Model	Applicable To	File Under	Bulletin No.
1997 PRELUDE	ALL	BODY	97-039
			Issue Date MAY 1997

Service Manual Update: Mirror Replacement

The 1997 Prelude Service Manual incorrectly describes the *Mirror Replacement* procedure. Make a note on the correct service manual page in the Body section to refer to this service bulletin.

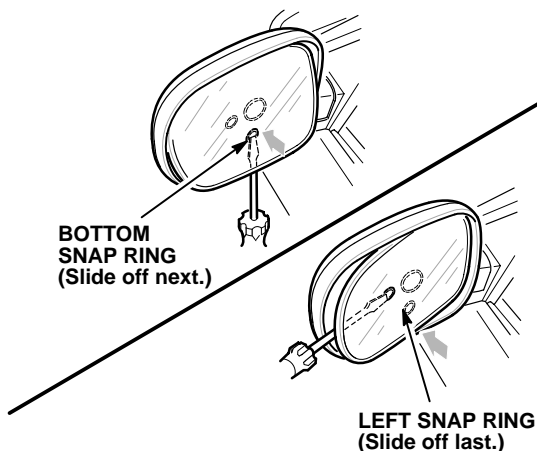
1. Pivot the mirror to access the center ball/socket from the top.

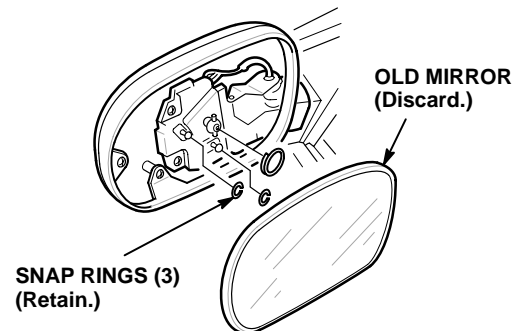
2. Slide the snap ring off the center mirror socket, and pry lightly with a flat-tip screwdriver on the mirror to separate the ball from the socket.
3. Repeat the procedure for the bottom worm-drive ball/socket, then the left ball/socket. Make sure you follow this order to prevent damaging the actuator.

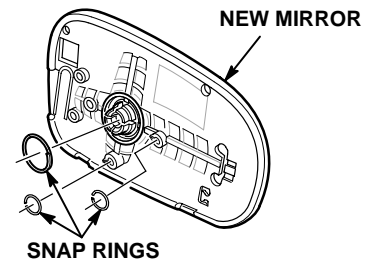
4. Remove the mirror, and retain the snap rings.

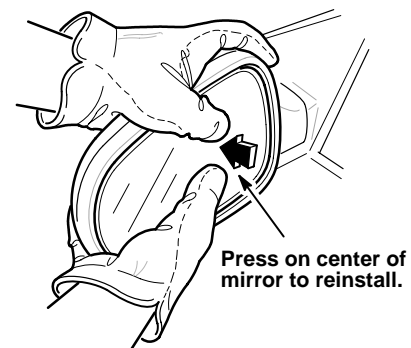
6. Press on the center of the mirror to reconnect each ball/socket. To prevent the glass from breaking, do not apply excessive pressure on the sides of the mirror.
